2.0 CHANGES TO THE PHASE 3 PROJECT AND MASTER RESPONSES TO COMMENTS ON THE DEIS/DEIR

2.2 MASTER RESPONSES TO COMMENTS ON THE DEIS/DEIR

Levee Prism Concept for the Sacramento River East Levee

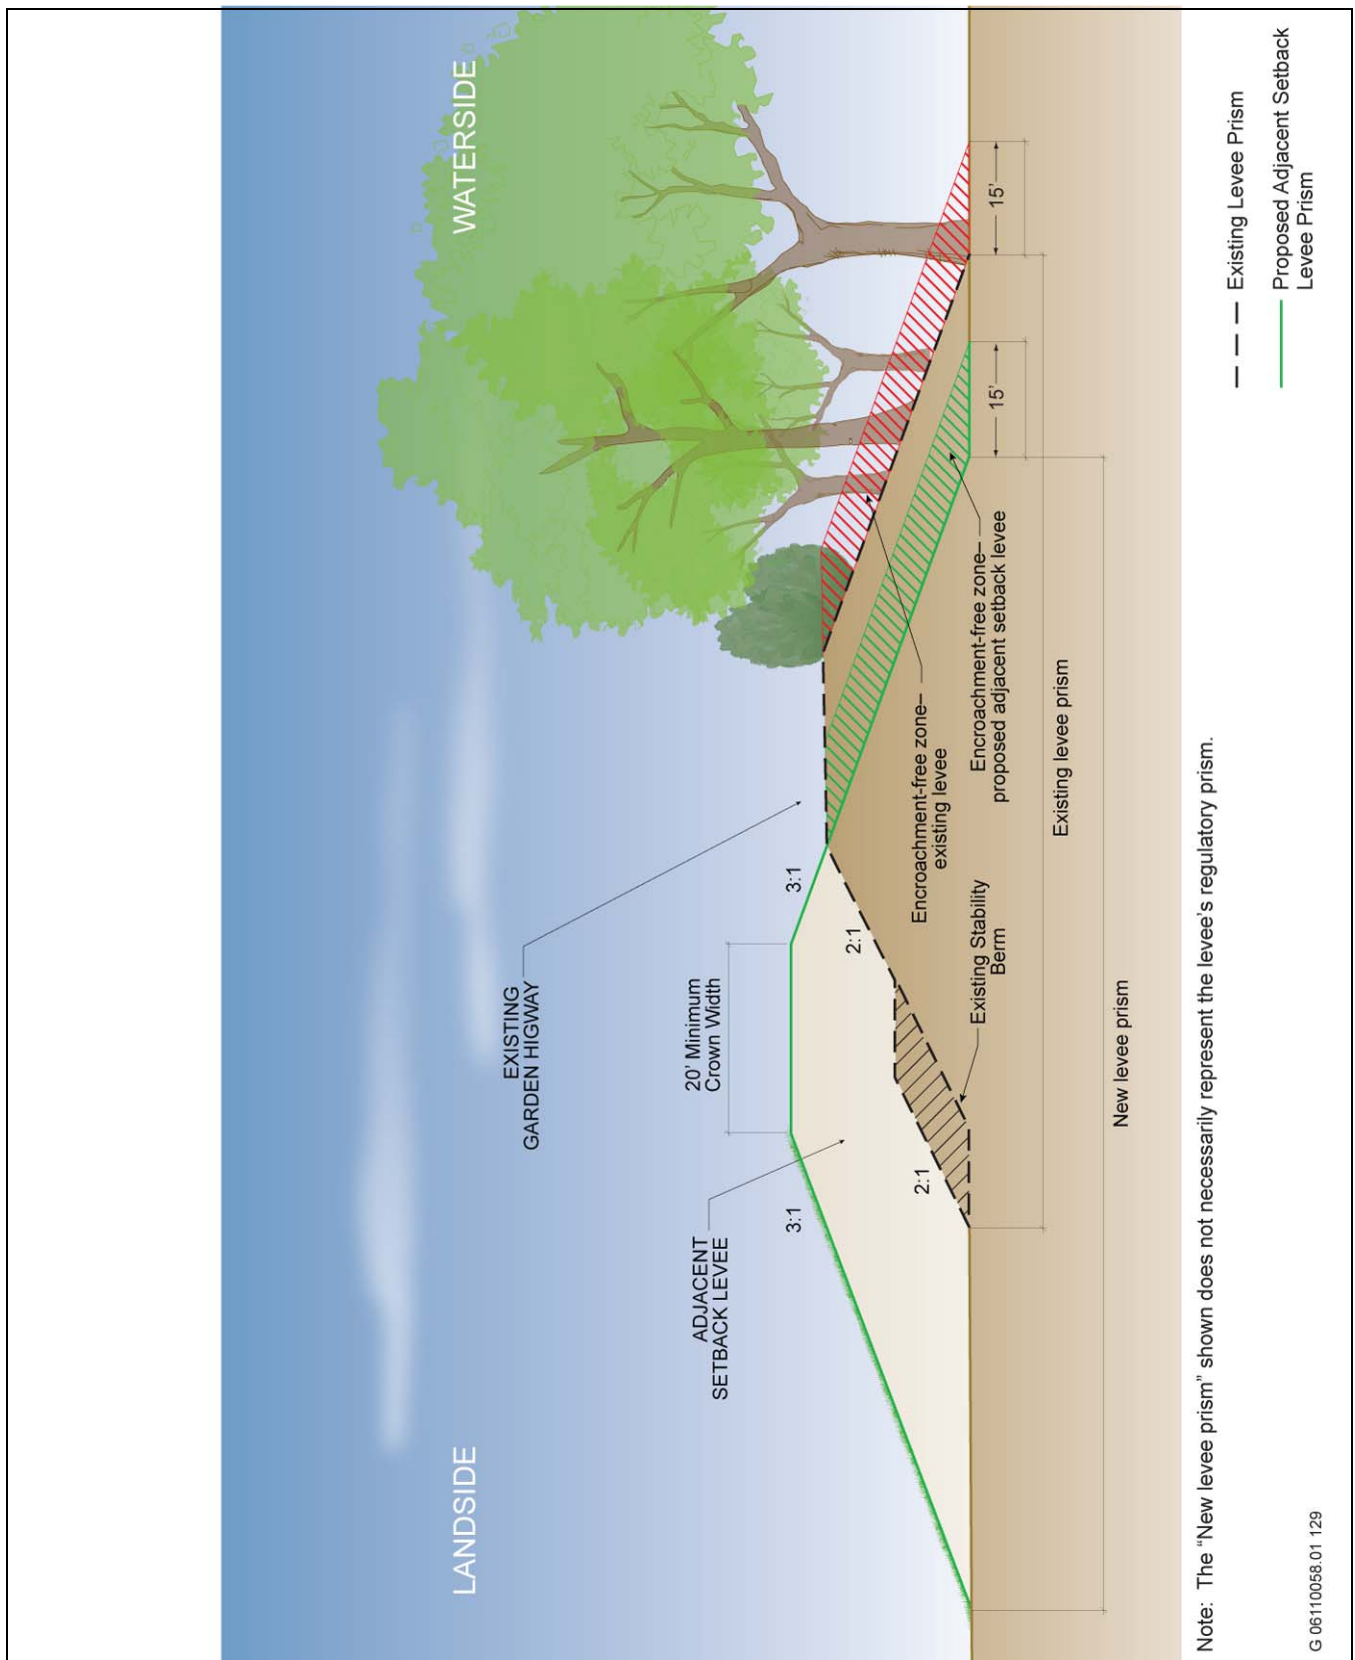
Several comment letters stated that the Phase 3 DEIS/DEIR did not provide enough information to fully explain the levee prism concept, the adjacent setback levee footprint, and potential construction-related impacts to vegetation and improvements. SAFCA has prepared the following response regarding the levee prism.

Plate 4 shows a typical profile view of the existing levee along the east side of the Sacramento River in comparison to the adjacent setback levee proposed for the Phase 3 Project (Reaches 5A–9B). The prism for the existing levee consists of:

- ▶ the levee crown (a minimum of 20 feet wide), on which the Garden Highway currently sits;
- ▶ a landside levee slope, typically 2H:1V
- ▶ a landside stability berm; and
- ▶ a waterside slope that is defined by a projected 3H:1V slope from the waterside hinge point of the levee crown that may or may not be exposed depending upon natural ground surfaces and property improvements, such as construction fill for foundations and driveways.

- ▶ a minimum 20-foot crown,
- ▶ a 3H:1V landside slope from the hinge point of the levee crown,
- ▶ an exposed upper waterside slope from the hinge point of the adjacent levee crown to the landside of Garden Highway, and
- ▶ the continuation of a projected (non-exposed) minimum 3H:1V waterside slope through the existing levee to a point that would be set back a minimum of 15 feet from the existing waterside toe.

The setting back of the Sacramento River east levee under the Proposed Action would provide the USACE-required 15 feet of clearance of encroachments (including vegetation greater than 2 inches in diameter) from the theoretical waterside toe of the new adjacent setback levee. As shown on **Plate 4**, this approach would shift the encroachment-free zone landward, potentially reducing the extent to which USACE, the State, SAFCA, and RD 1000 would require the removal of existing encroachments to meet this requirement under the Levee Raise-in-Place Alternative. The impact of the removal of waterside vegetation greater than 2 inches that would potentially occur in the event of that the adjacent setback levee would not be constructed was analyzed in the Phase 3 DEIS/DEIR under Impact 4.8-a, “Loss of Woodland Habitats,” under the Levee Raise-in-Place Alternative. This loss was estimated to be up to 22 acres for Reaches 5A–9B.
